COMPANY NAME	West Coast Regional Council
ATTENTION	Rachel Clark, Rebecca Inwood
SUBJECT	Mananui Mineral Sands Project – Hydrological Review

The WCRC has commissioned Wallbridge Gilbert Aztec (WGA) to review the technical documents lodged in support of the application. The review by WGA covers the hydrological and hydrogeological aspects of the application.

This technical memorandum documents the outcomes from an initial review of the documents listed below. The objective of this review is to determine if there are any gaps in information and to provide requests for information under Section 92 of the Resource Management Act.

Figure 2. Site water balance diagram with flows in m³/hour (from Kōmanawa 2023a)

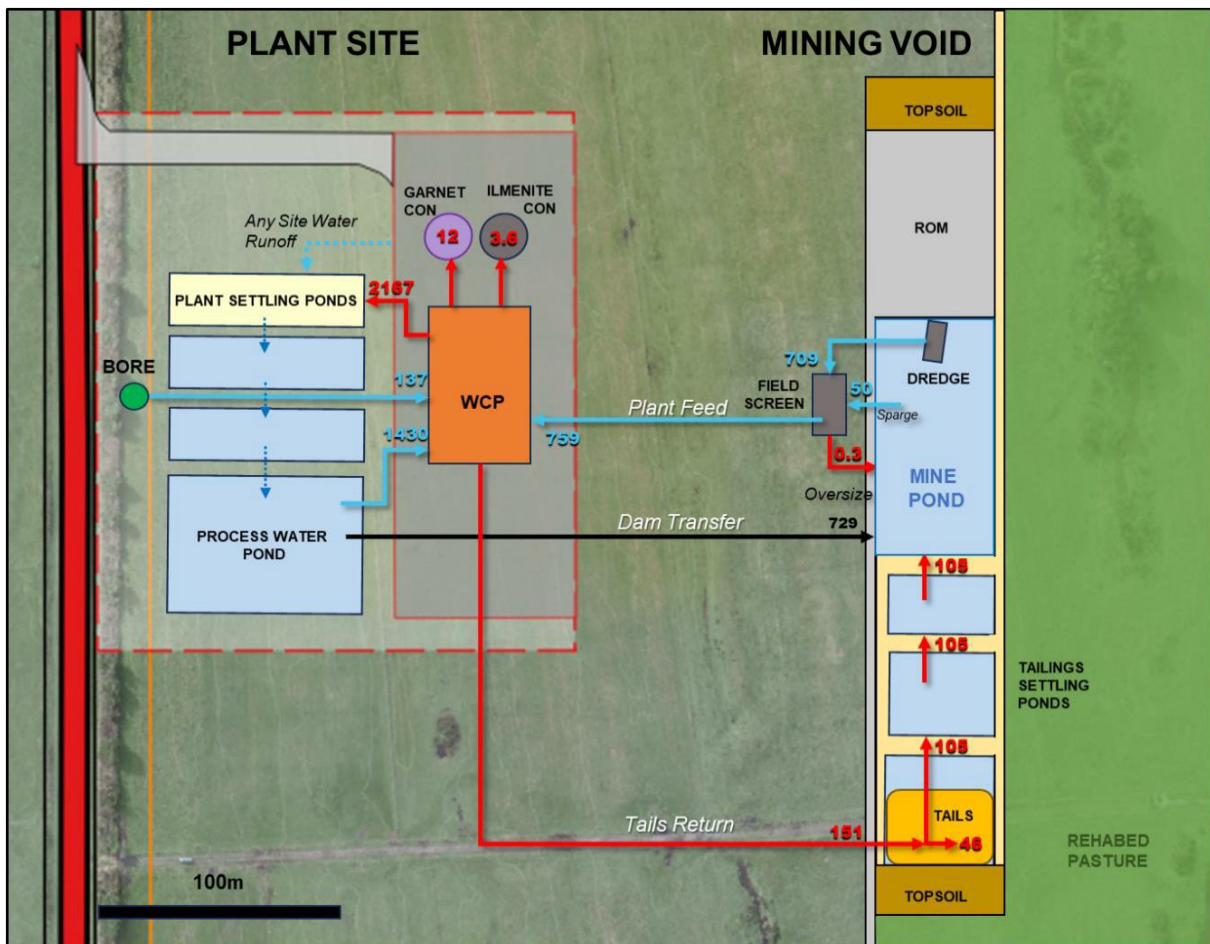
7. Please clarify why a top-up pumping rate from the proposed bore of 137 m³/hour is required, when the mass balance presented in Table 4-6 indicates a net positive flow into the dredge pond of 121 m³/hour. The report states that the groundwater model indicates a loss of about 7 L/s or 25 m³/hour to Tūwharewhare. Another 16 m³/day is lost from site with the processed ore. These seem to be the only uncontrolled water losses from site. The flows to the infiltration trench at the southern edge of the site are controlled losses and only occur when required. Therefore, why does the top-up water flow exceed 31 m³/day?

8. Please adjust the outflow rates from the dredge pond to Tūwharewhare from 7 L/s to 9 L/s, as this latter value represents the maximum increase in flow to Tūwharewhare indicated by mine water management Scenario 2 (Figure 6-15).
